PIC18(L)F1XK22 Family Silicon Errata and Data Sheet Clarification

The PIC18(L)F1XK22 family devices that you have received conform functionally to the current Device Data Sheet (DS40001365F), except for the anomalies described in this document.

FIGURE 1: INSTRUCTION CYCLE DELAY CALCULATION EXAMPLE

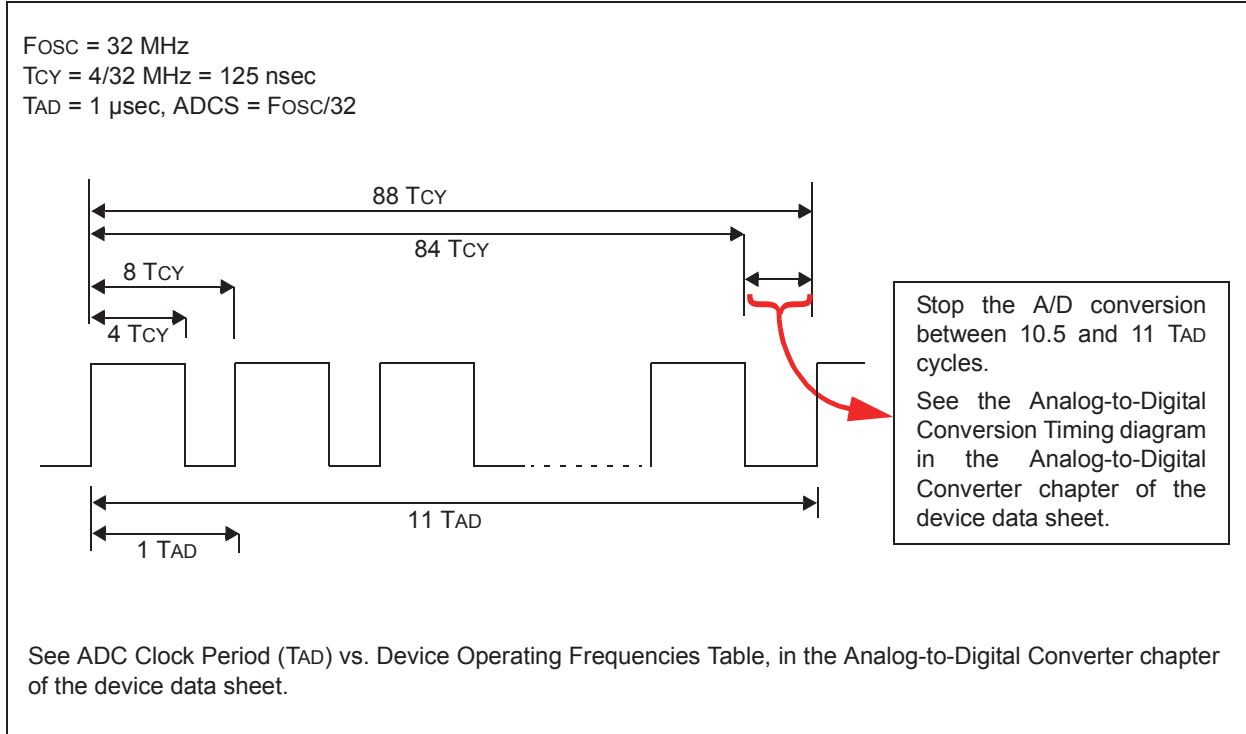
Method 3: Method 3 is provided if the application cannot use Sleep mode and requires continuous operation at frequencies above 8 MHz. This method requires early termination of an ADC conversion. Provide a fixed time delay in software to stop the Analog-to-Digital conversion manually, after all ten bits are converted, but before the conversion would complete automatically. The conversion is stopped by clearing the GO/DONE bit in software. The GO/DONE bit must be cleared during the last ½ TAD cycle, before the conversion would have completed automatically. Refer to [Figure 1](#) for details.

In Figure 1, 88 instruction cycles (T_{CY}) will be required to complete the full conversion. Each T_{AD} cycle consists of eight T_{CY} periods. A fixed delay is provided to stop the A/D conversion after 86 instruction cycles and terminate the conversion at the correct time as shown in the figure above.

Note: The exact delay time will depend on the T_{AD} divisor (AD_{CS}) selection. The T_{CY} counts shown in the timing diagram above apply to this example only. Refer to Table 3 for the required delay counts for other configurations.
